ADDENDUM #4

Essexville-Hampton Public Schools
New Innovation Center Project
September 14, 2026

Project: EHPS New Innovation Center Project

RE: Pre-Bid RFI Response

6 Eyewash Detail

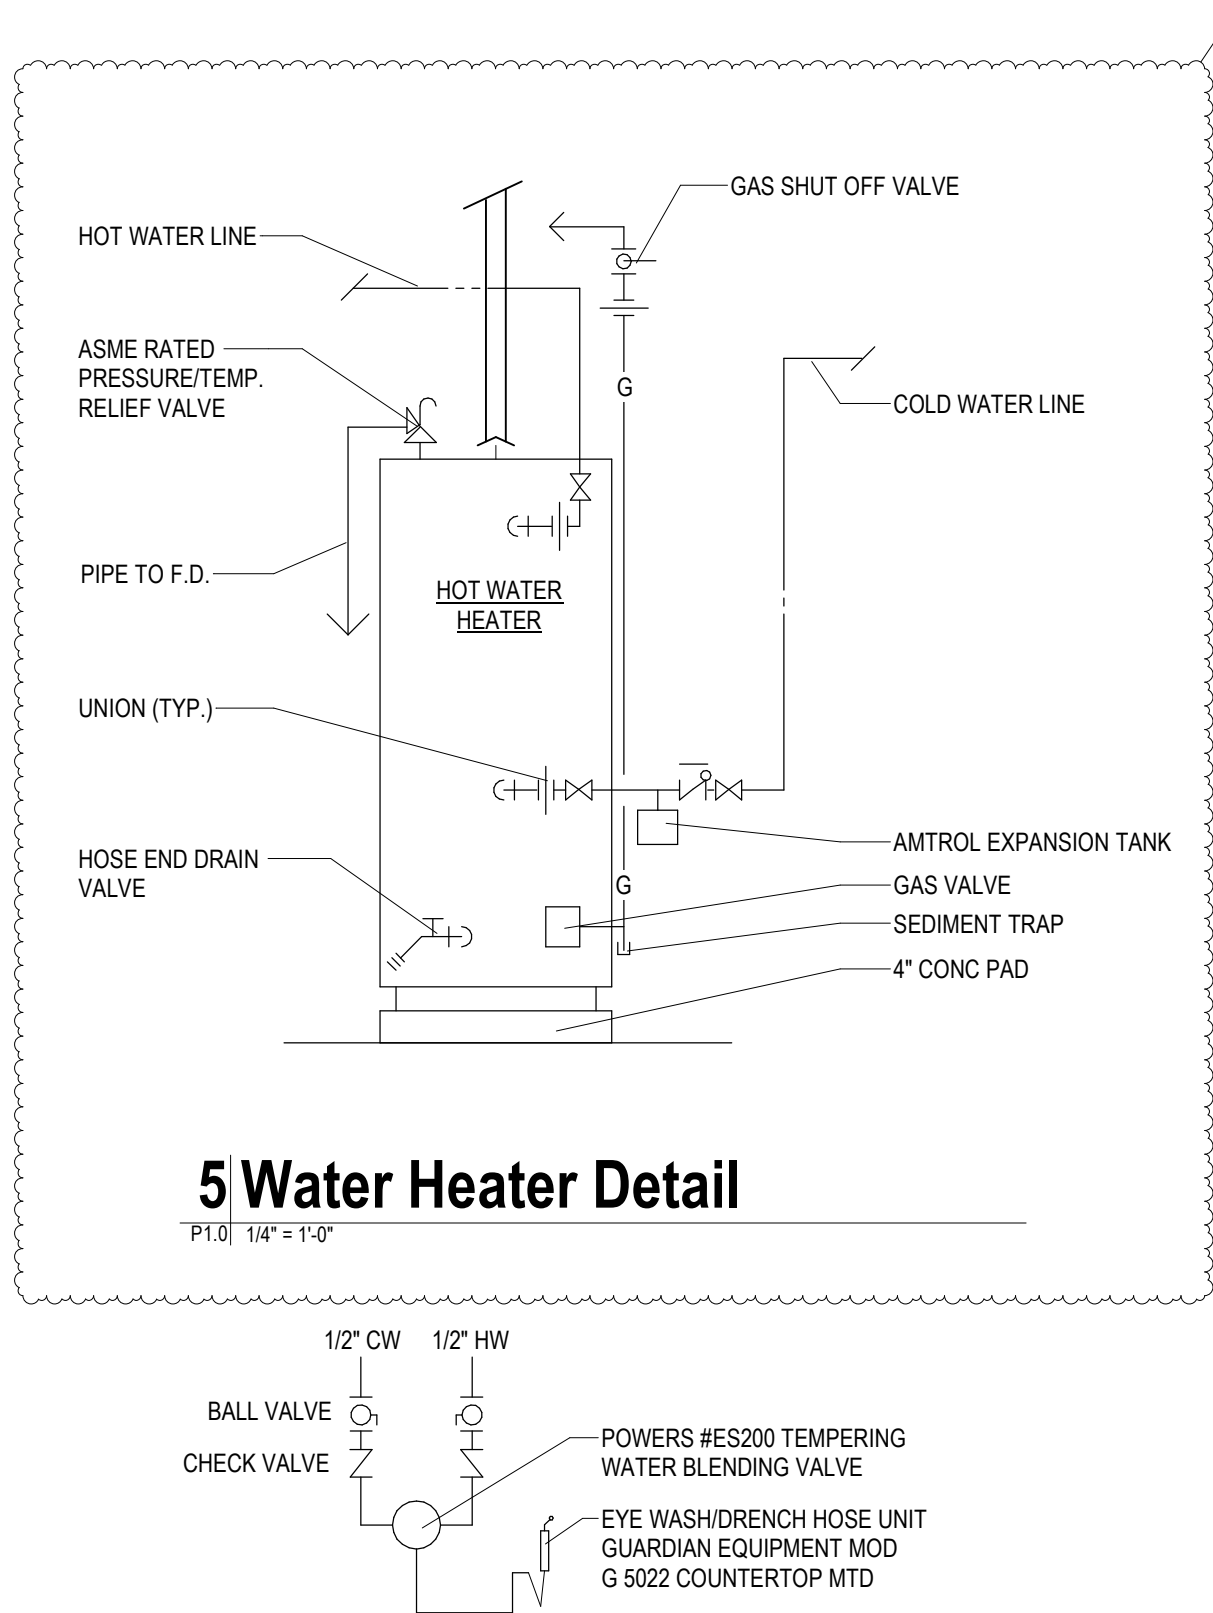
1. I'm looking for some clarification about the domestic hot water for this project. On P1.0 the water heater detail shows a recirculating pump and recirculating hot water line, but the drawing does not show a recirculating hot water line. Are we to figure it with a recirc line or omit it?
 - a. There is no recirculating pump - refer to updated detail 5/P1.0 - Plumbing Plan.

Drawing
Electrical Plan

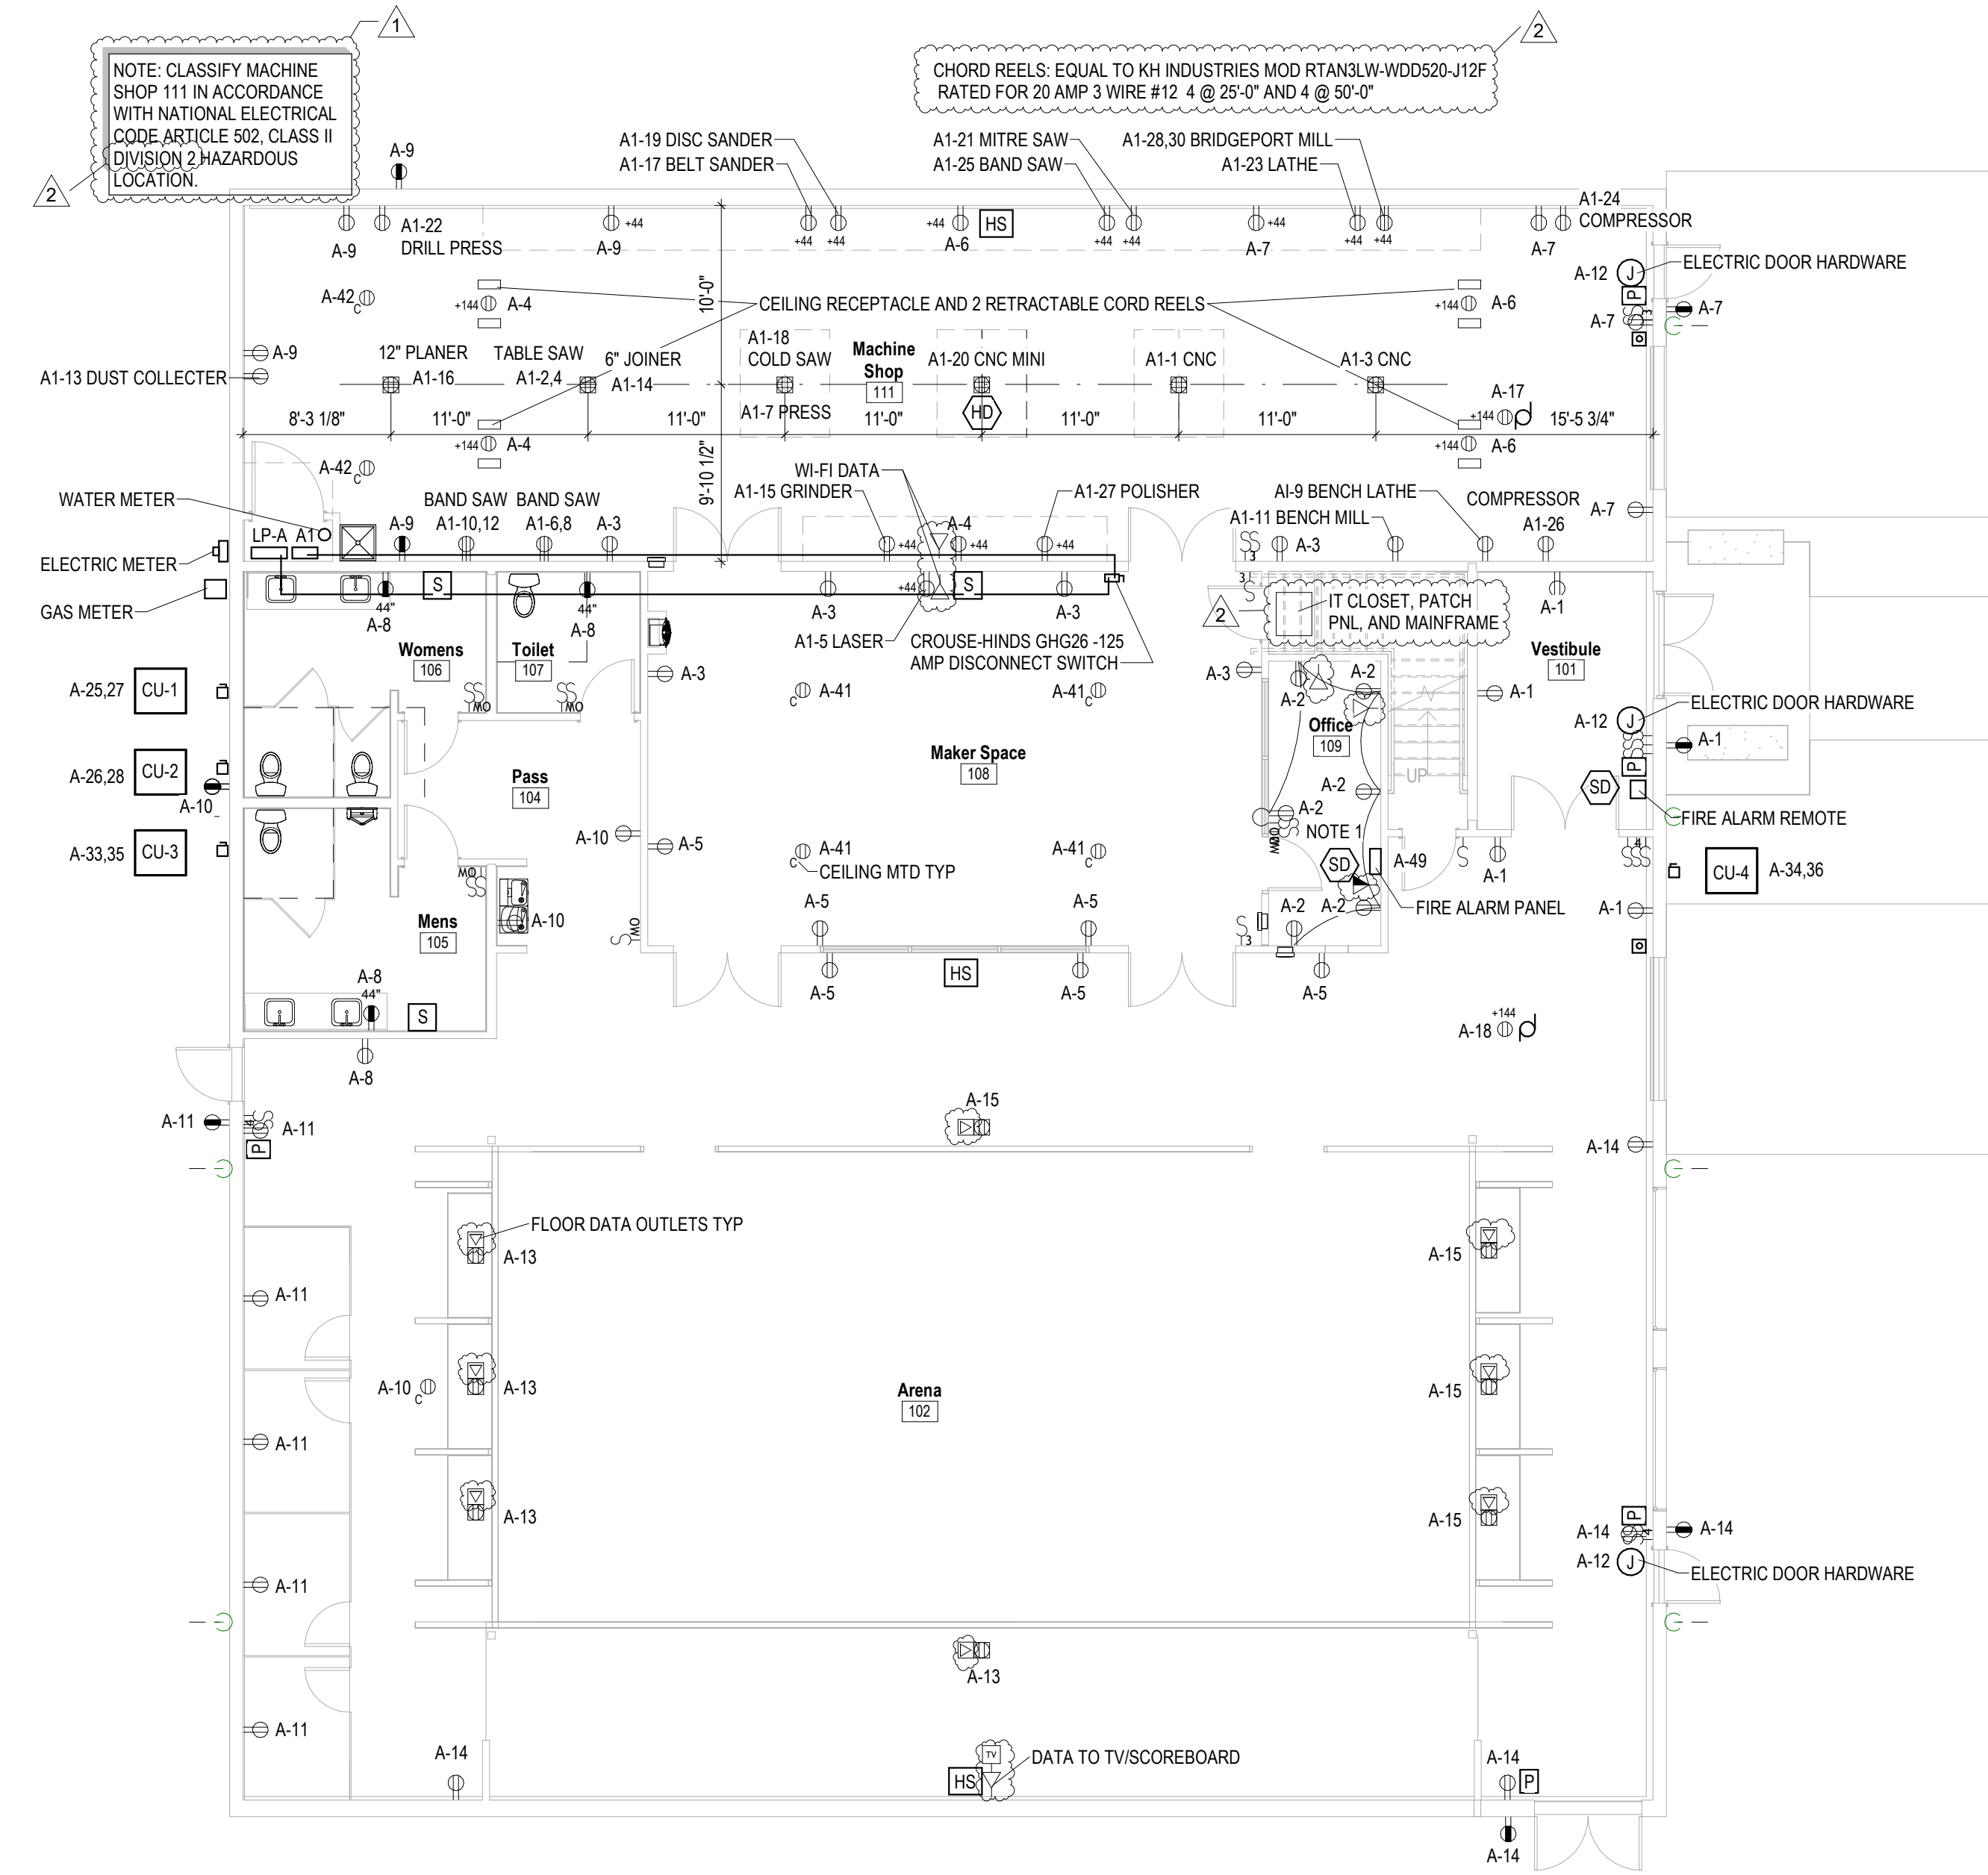
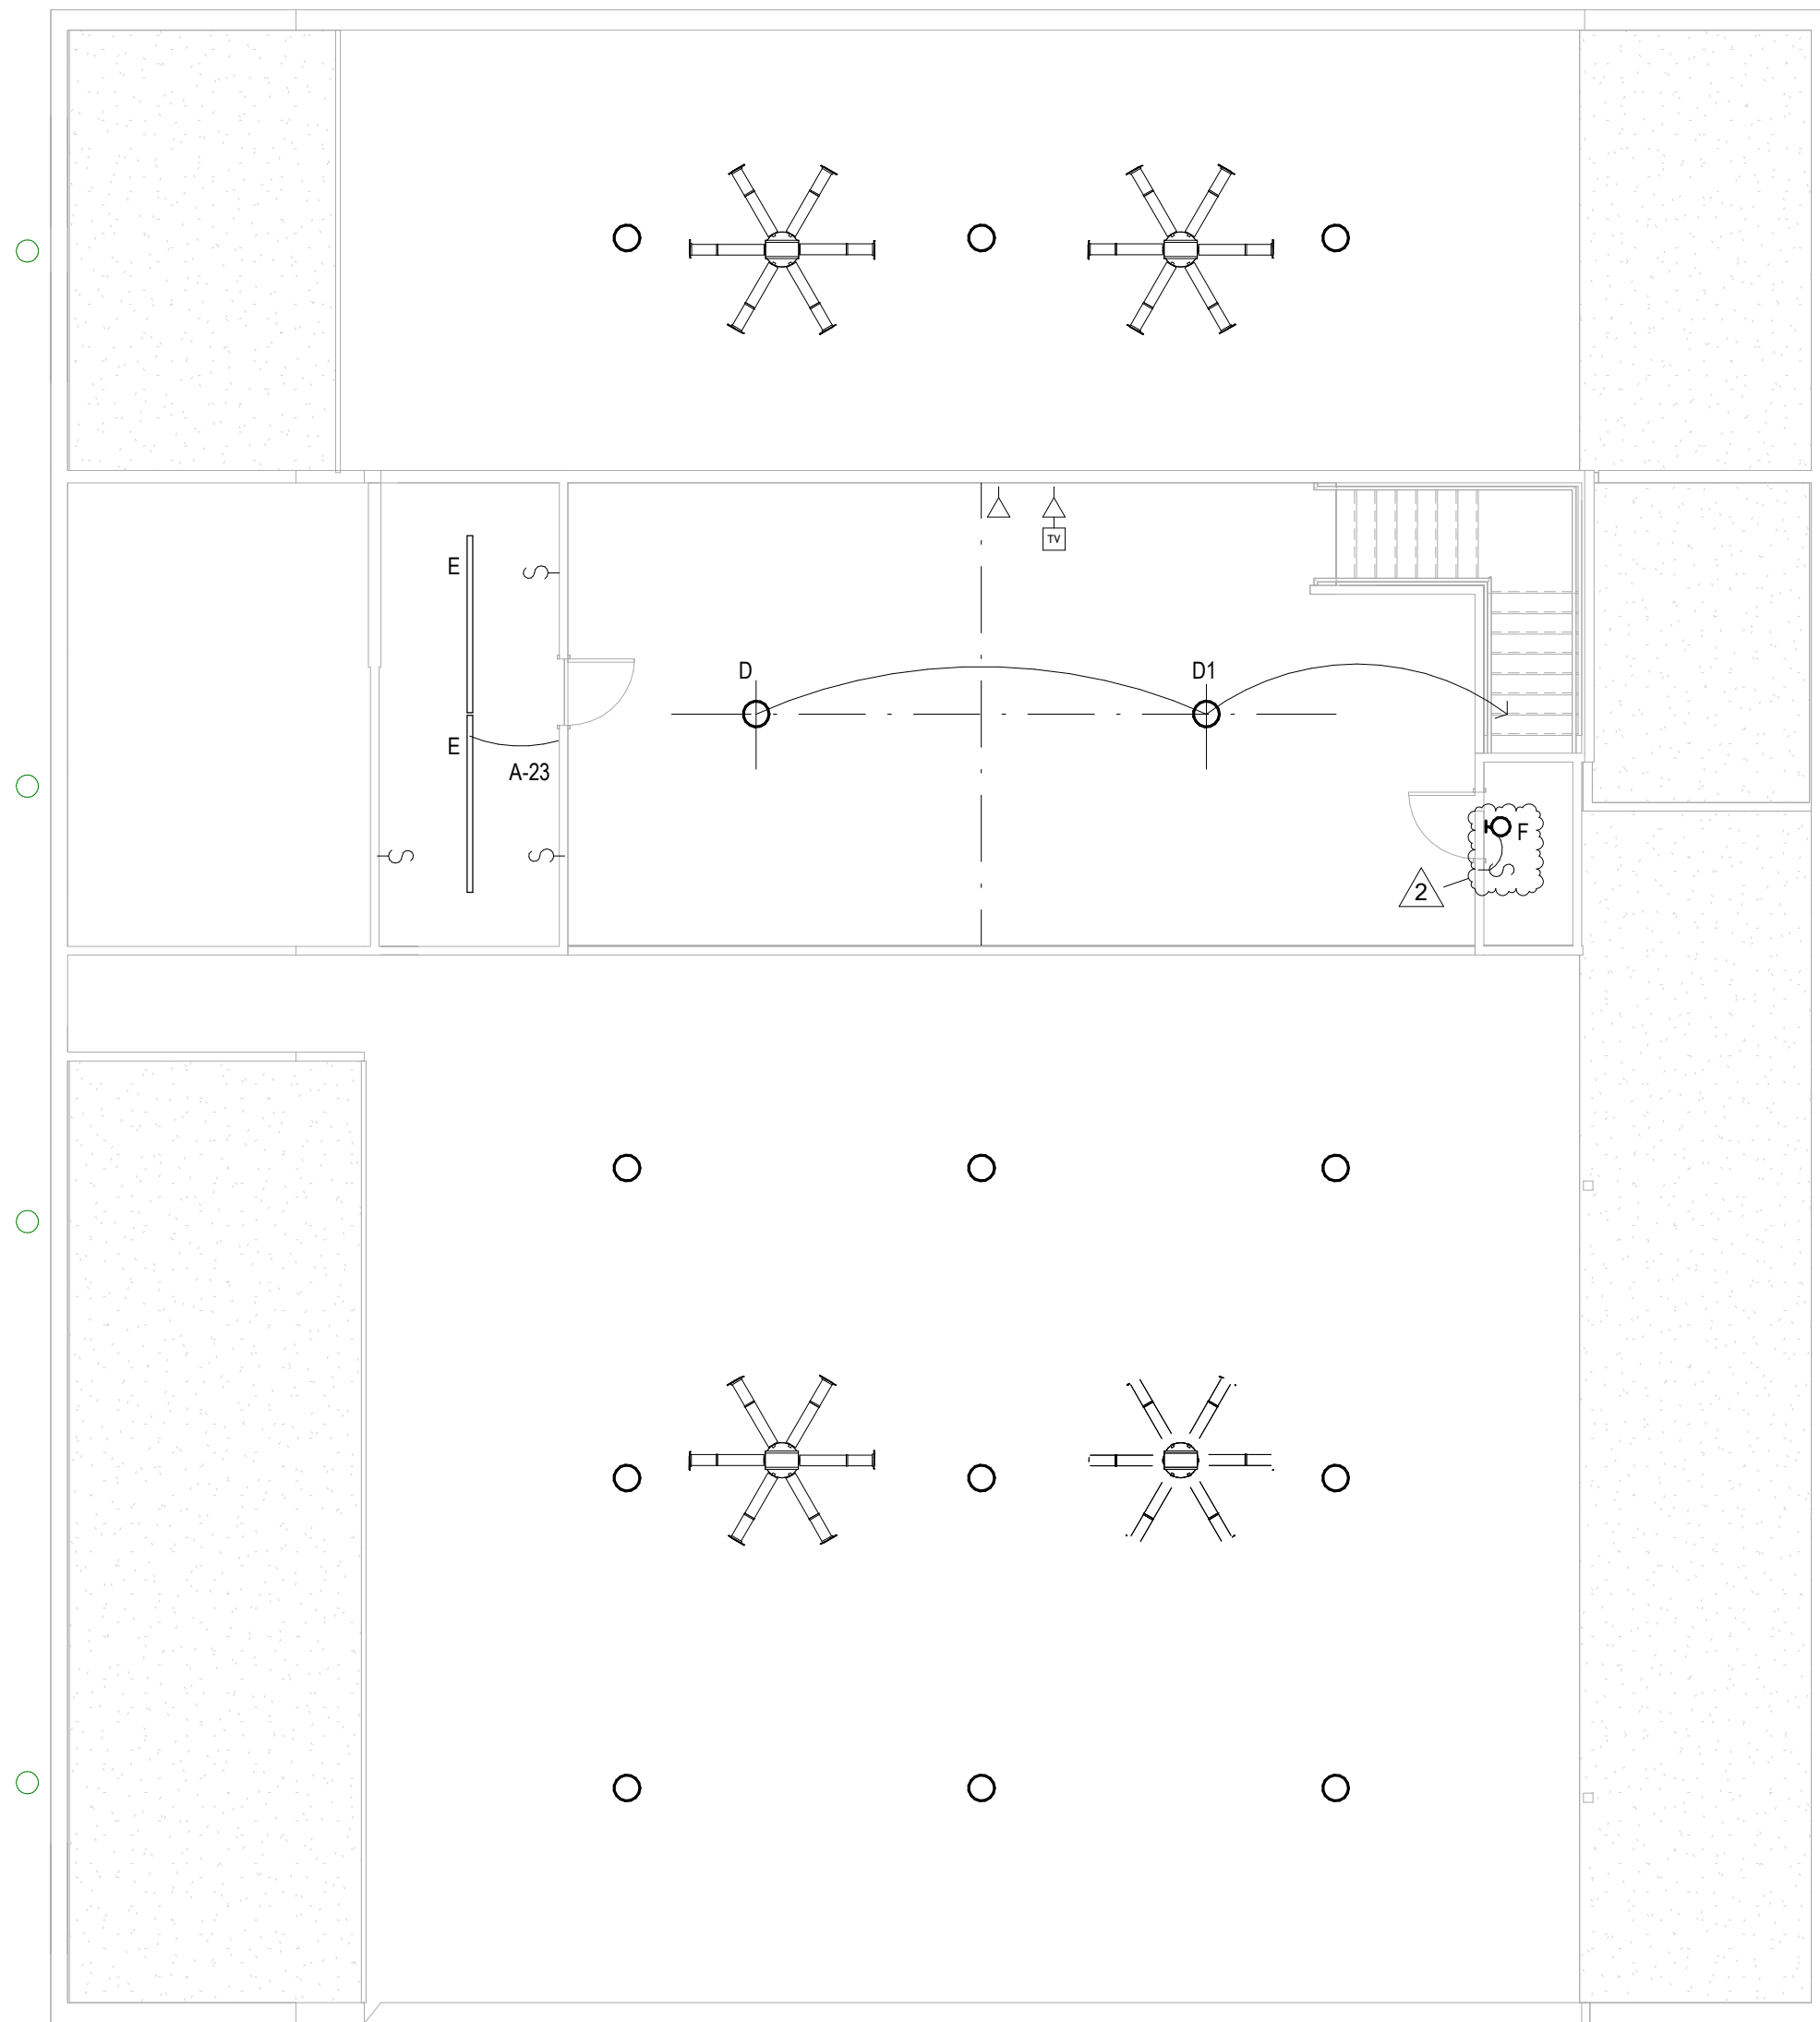
1. I show NO Voice / Data either entering the building, IT Room or Drops.
 - a. Data has been included on re-issued sheet E1.0 - Electrical Plan.

1. Drawing E1.0 states Machine Shop 111 is to be classified as a Class II hazardous location; does it fall under Division 1 or 2?
 - a. Division 2.
2. Drawing E1.0 also shows floor receptacles in Machine Shop 111 as well as Arena 102; in-grade floor receptacles are generally not permitted in Class II hazardous locations, should we assume pedestal mount receptacles meeting the Class II requirements (i.e. NEMA 4/4x/Etc)? And should this apply to Arena 102 (less the hazardous location requirements) as there is no floor box spec?

- a. Utilize NEMA 4/4x BOD is acceptable in Machine Shop 111. Utilize Access Floor Systems IEBSX for Arena 102 BOD.
3. Who is to supply / install the cord reels shown on E1.0? (No spec or info given).
